SUBJECT: ISSUANCE OF AMENDMENT (TAC NO. M79289)

The Commission has issued the enclosed Amendment No. 164 to Facility Operating License No. DPR-50 for the Three Mile Island Nuclear Station, Unit No. 1, in response to your letter dated November 14, 1990, as supplemented by letters dated June 6, June 14, September 18, November 27, and December 12, 1991, and February 13, 1992.

The amendment revises the TMI-1 Technical Specifications to reflect planned reracking of the "A" Spent Fuel Pool to allow additional storage capacity.

Amendment No. 164
License No. DPR-50

Figure 5-4 **Relationship between Initial Enrichment and** Acceptable Fuel Burnup (Spent Fuel Pool A - Region II)

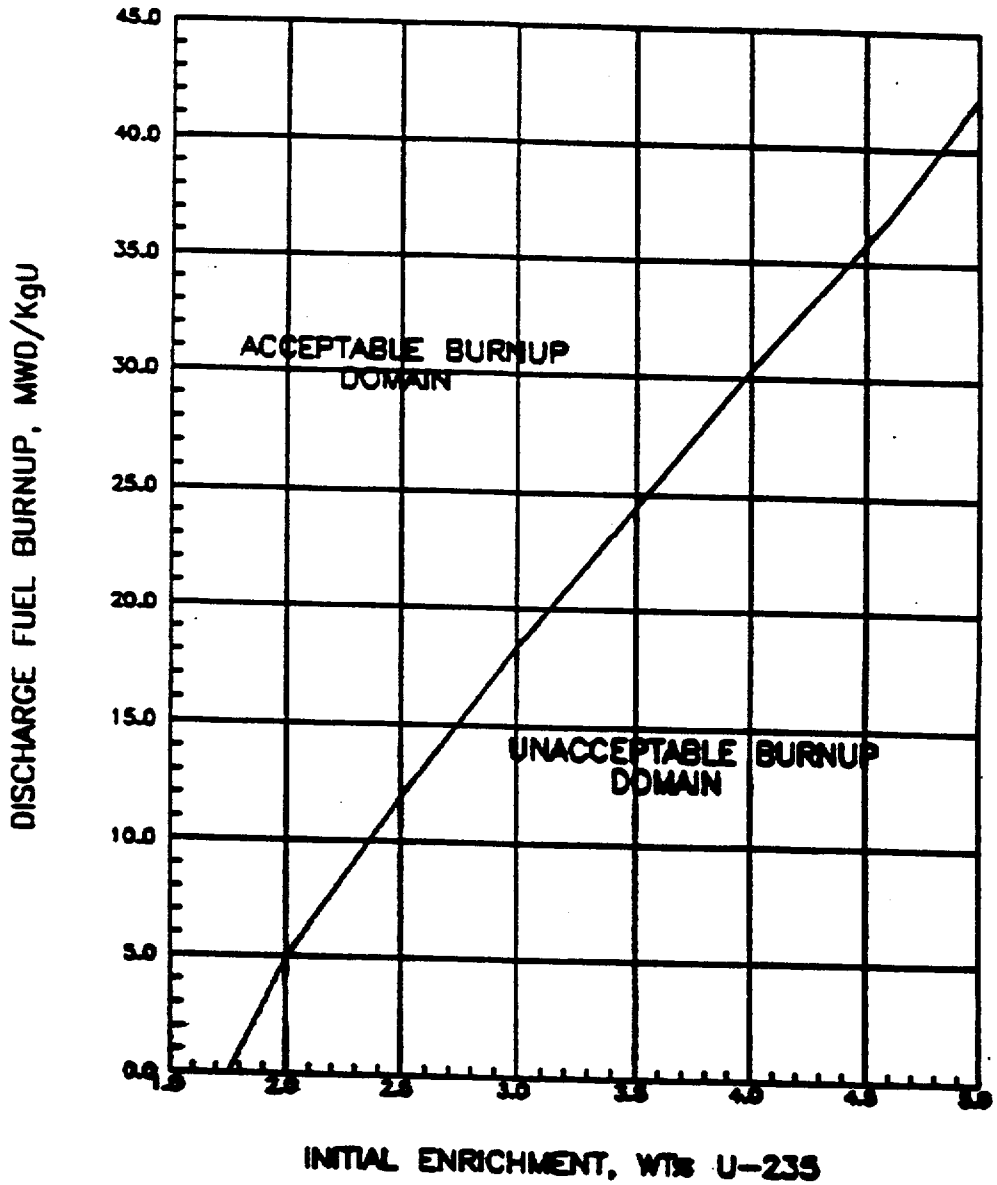
g. When spent fuel assemblies are stored in Region II storage racks of the Spent Fuel Pool "A", the combination of initial enrichment and cumulative burnup for spent fuel assemblies shall be within the acceptable area of Figure 5-4.

(4) TS 5.4.2.g and Figure 5-4 are added to provide administrative controls to limit storage of spent fuel assemblies in Region 2 of the SFP A storage racks based on initial enrichment and cumulative exposure.
